ARC REVIEW CODE: R1904221

Name of Proposal: Gardner 42 Expansion (DRI 2939)

DRI SITE PLAN

DRI #2939

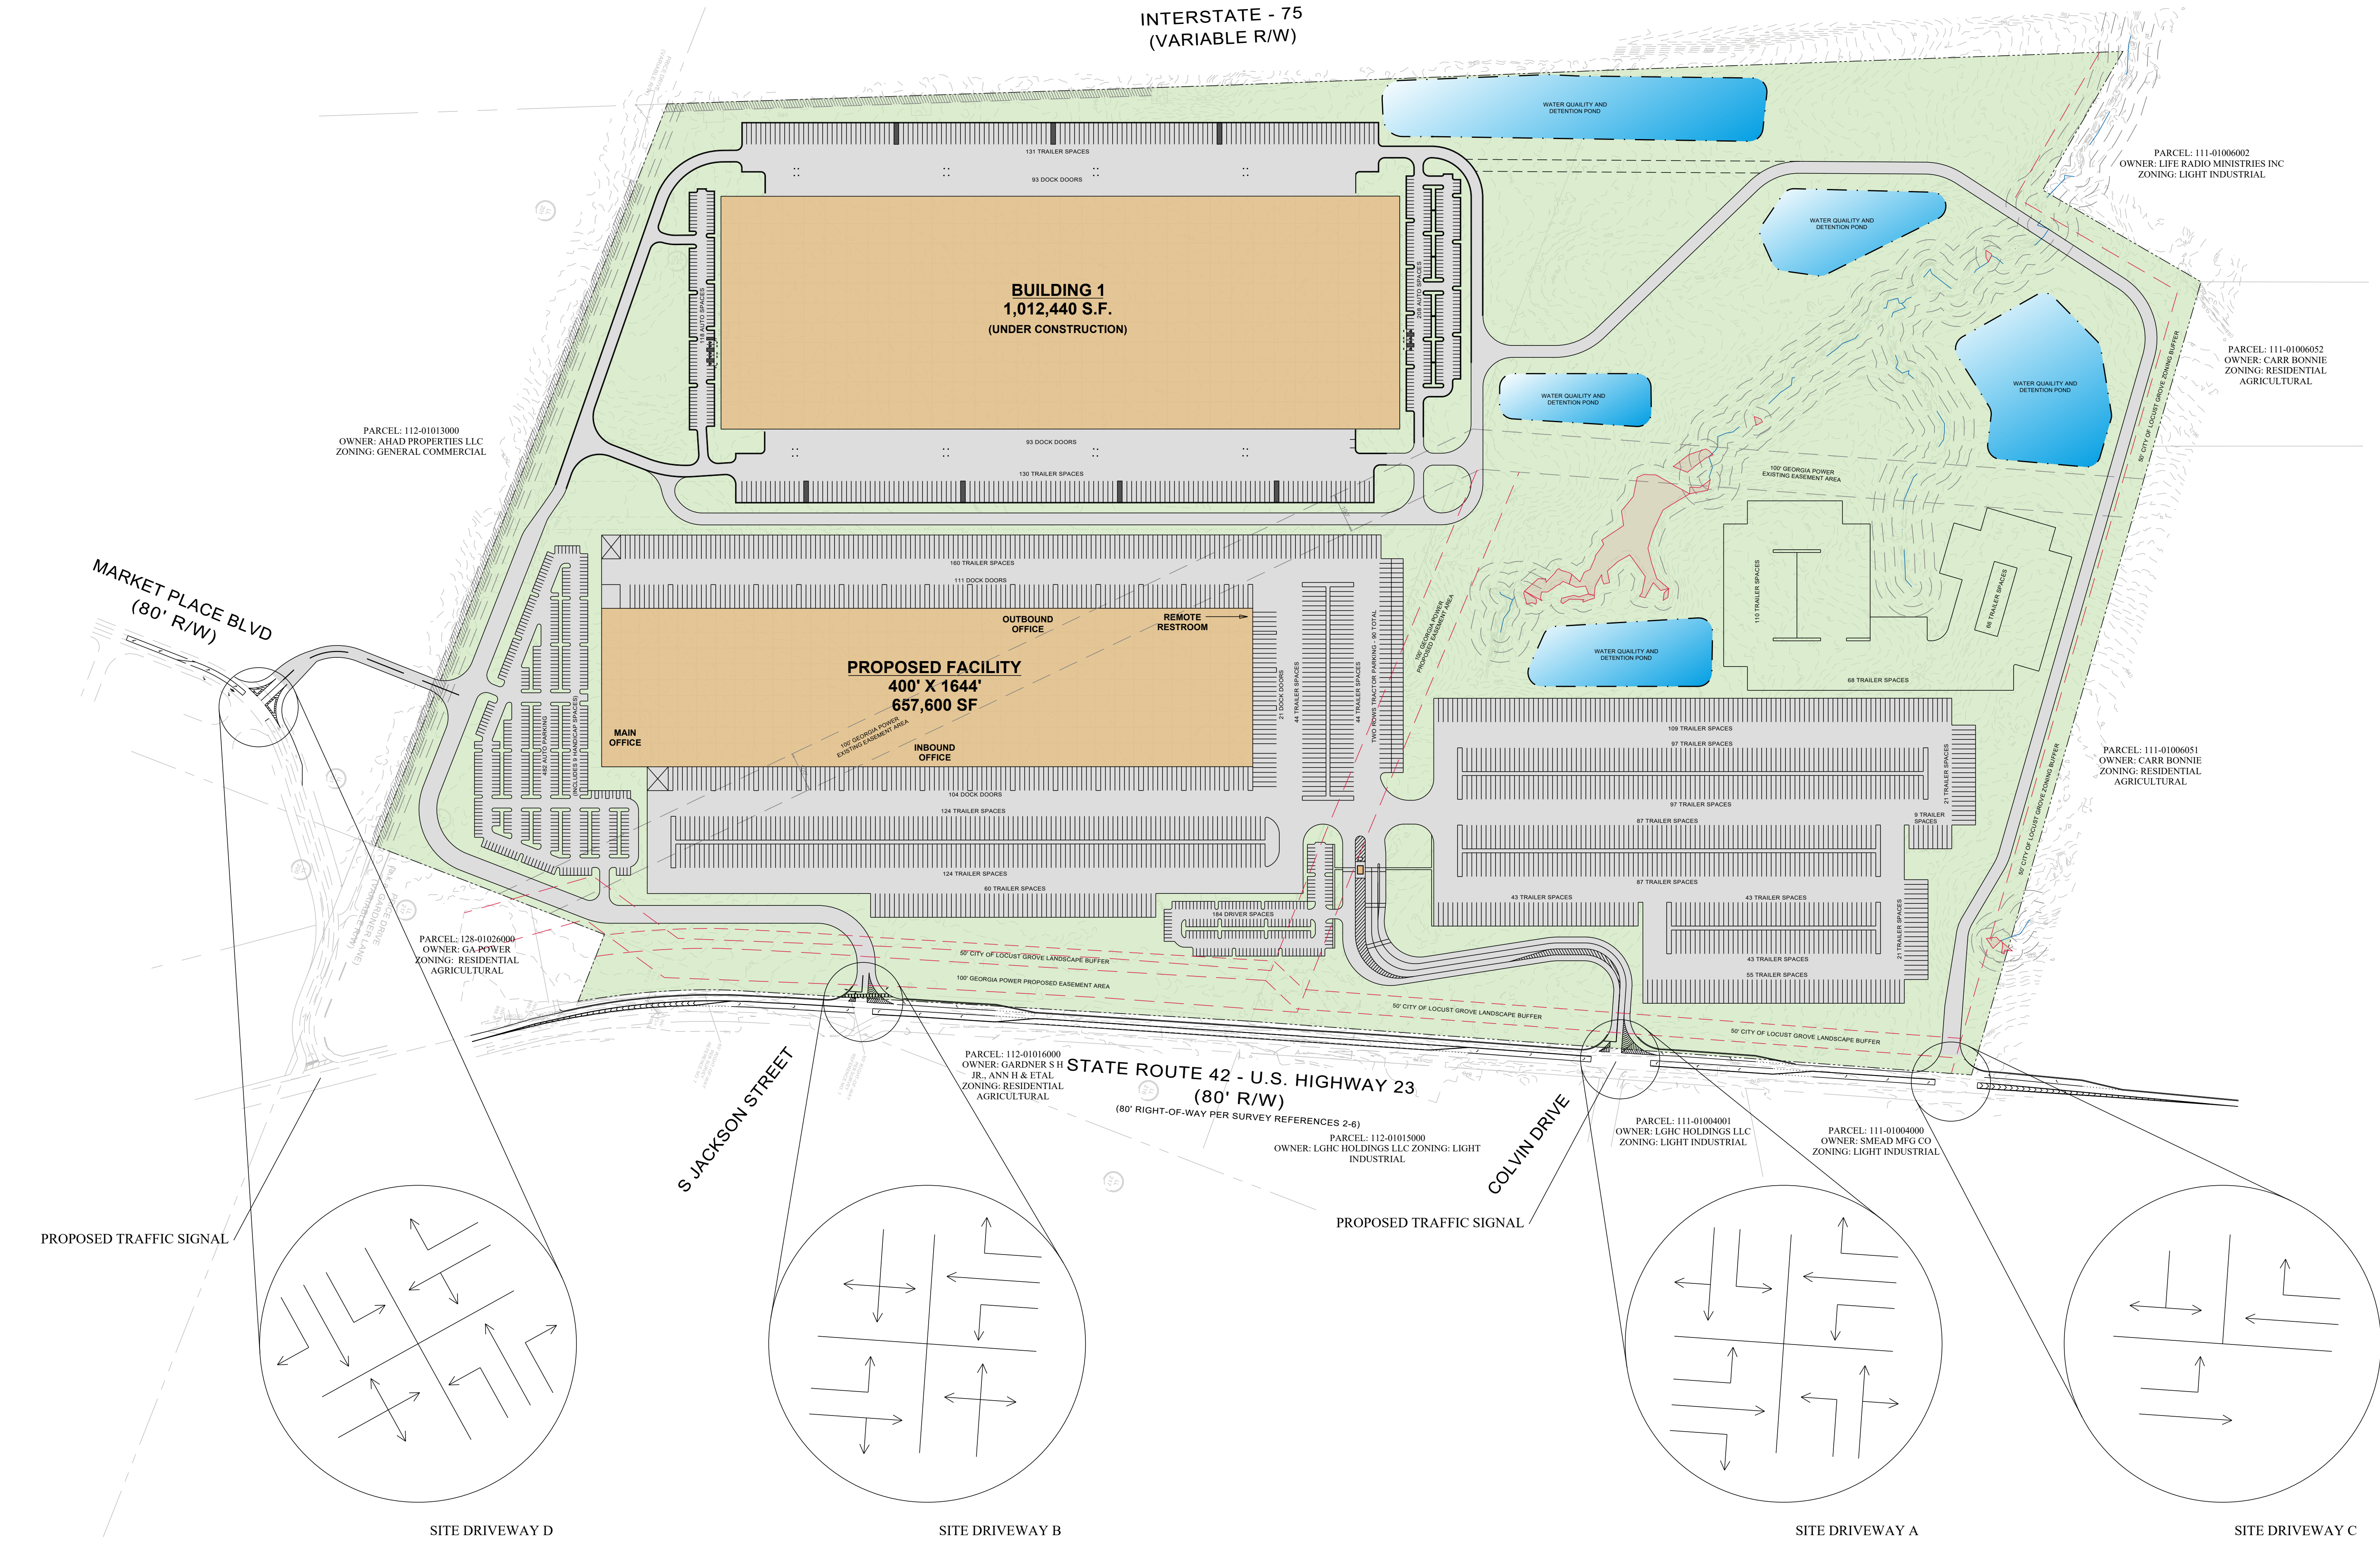
No stubouts are proposed. Market Place Blvd, a local road, provides access to adjacent parcels, Vehicles will have to access adjacent parcel by SR 42.

The development doesn't propose internal or external sidewalk facilities.

The site plan does show proposed internal walkways from parking to structures.

All four driveways proposed allow for shared access and maneuvering of vehicle and freight traffic .

The development should consider constructing pedestrian facilities such as sidewalks on site frontage along SR 42.
